DEPARTMENT OF TRANSPORTATION**DIVISION OF ENGINEERING SERVICES**

Contract #: 04-0120F4Cty: SF/ALA Rte: 80 PM: 13.2/13.9File #: 1.28**WELDING INSPECTION REPORT****Resident Engineer:**Pursell, Gary**Address:** 333 Burma Road**City:** Oakland, CA 94607**Report No:** WIR-016404**Date Inspected:** 23-Aug-2010**Project Name:** SAS Superstructure**OSM Arrival Time:** 1000**Prime Contractor:** American Bridge/Fluor Enterprises, a JV**OSM Departure Time:** 1830**Contractor:** American Bridge/Fluor Enterprises, a JV**Location:** Job Site

WELDING INSPECTION REPORT

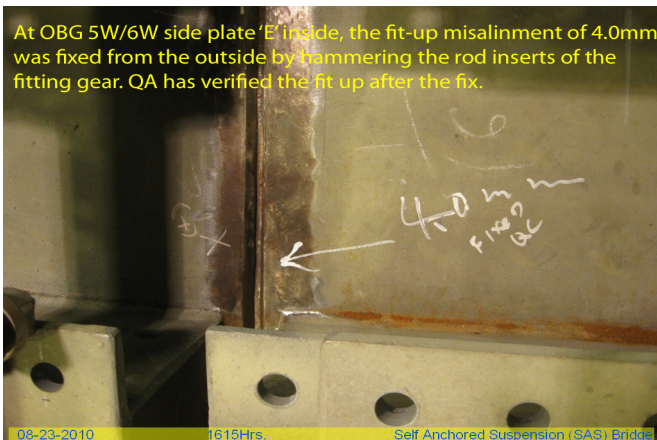
At OBG 5W/6W side plate 'E' inside, fit-up misalignment of 4.0mm was noted during the QA verification. QC acknowledged the misalignment and instructed the fit-up crew to fix the unacceptable high/low.

At OBG 5W/6W side plate 'E' inside, ABF QC William Sherwood has confirmed the existence of fit-up misalignment of the splice joint. He then instructed the fit-up crew to fix the unacceptable misalignment. Later, the fit-up crew was noted hammering the rod inserts of the fitting gears to make the adjustments. QC has re-measured the high/low and has come to acceptable level. QA has also verified the alignment after the adjustment.

At OBG 5W/6W side plate 'E' inside, the fit-up misalignment of 4.0mm was fixed from the outside by hammering the rod inserts of the fitting gear. QA has verified the fit up after the fix.
